Access Compliance Report

Public Rights-of-Way

(Curb Ramps)

Intersection ID: 10957	Main Street: CRISMAN_ST	Cross Street: PACIFIC_ST	Location: E
ADA ID: 080032874D11	Ramp Type: BlendTrans1	Initial Pass/Fail: Fail	Overall Compliance: No
Severity Score: 1.25			
Codes/Mitigation Info/Possible Solution		Field Measurements/Component Compliance

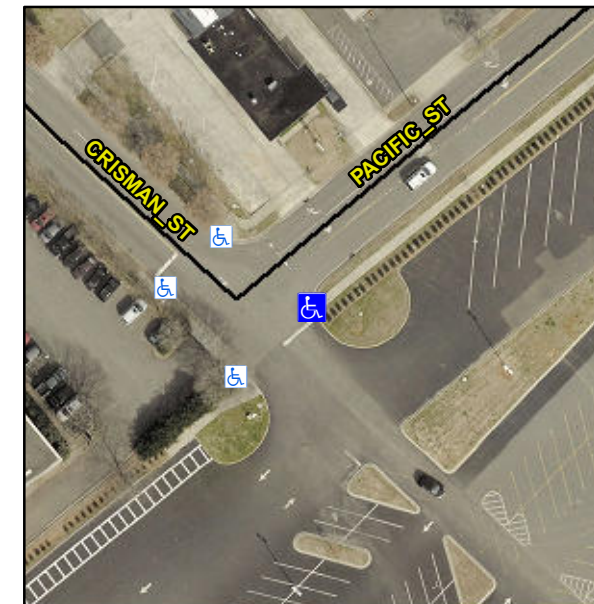
Not Found, R304.5.3

Compliance	Description	Data	Compliance	Description	Data
N/A	Ramp Length (in)	51.0	Yes	BlendTrans Slope (%)	2.3
Yes	Ramp Width (in)	73.0	No	BlendTrans XSlope (%)	2.8
N/A	Flare Type LT	N/A	N/A	Flare Type RT	N/A
N/A	Flare Slope LT (%)	N/A	N/A	Flare Slope RT (%)	N/A
N/A	Flare Traversable LT?	N/A	N/A	Flare Traversable RT?	N/A
N/A	Landing Length (in)	N/A	N/A	DWS Provided?	N/A
N/A	Landing Width (in)	N/A	N/A	DWS Contrast?	N/A
N/A	Landing Slope (%)	N/A	N/A	DWS Length (in)	N/A
N/A	Landing X Slope (%)	N/A	N/A	DWS Full Width?	N/A
N/A	Landing Curb? (Y/N)	N/A	N/A	DWS Offset (in)	N/A
N/A	Shared Landing?	N/A			
N/A	Gutter Ponding?	N/A	N/A	Gutter Slope (%)	N/A
N/A	Gutter Lip Ht (in)	N/A	N/A	Gutter X Slope (%)	N/A
N/A	Painted X Walk1?	No	N/A	Painted X Walk2?	No
	X Walk 1 Direction	To NW		X Walk 2 Direction	To SW
	X Walk 1 Width (in)	N/A		X Walk 2 Width (in)	N/A
	X Walk 1 Slope (%)	4.7		X Walk 2 Slope (%)	1.8
	X Walk 1 X Slope (%)	2.8		X Walk 2 X Slope (%)	5.0

N/A	Ramp inside XWalk1?	N/A	N/A	Ramp inside XWalk2?	N/A
	Road Slope (%)	0.9		Clear Space?	N/A
	Road X Slope (%)	4.2	N/A	Clear Space to XWalk (in)	N/A
N/A	Any Obstructions?	N/A	N/A	Storm Grate/Utility Hazard?	N/A
	Obstruction Type			Storm Grate/Utility Type	
		N/A			N/A
		Yes		Surface Condition? (G/P)	Good
		No		Curb Slope (%)	7.7

Remove & Replace Curb Ramp With Two New Directional Ramps or Equivalent.
